---

---

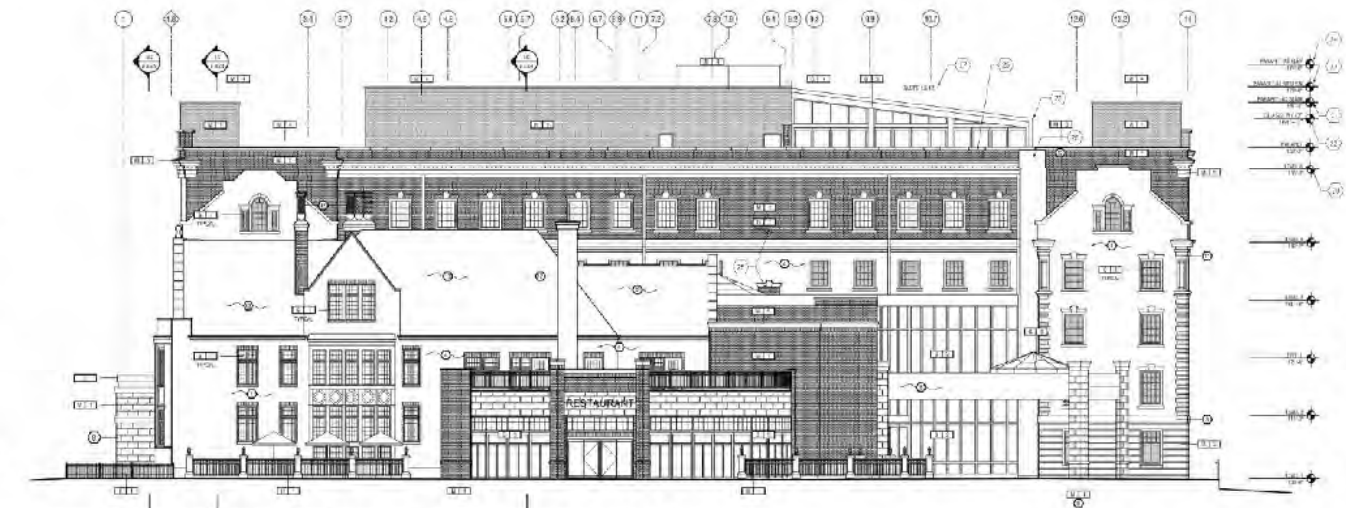
- GENERAL NOTE: The Historic Conservator Approved the Building Permit on 01/03/2019 with the following COMMENT:  
Plans substantially match the HCB approved Plans from July 13, 2015.  
Changes that are in keeping with the original design include
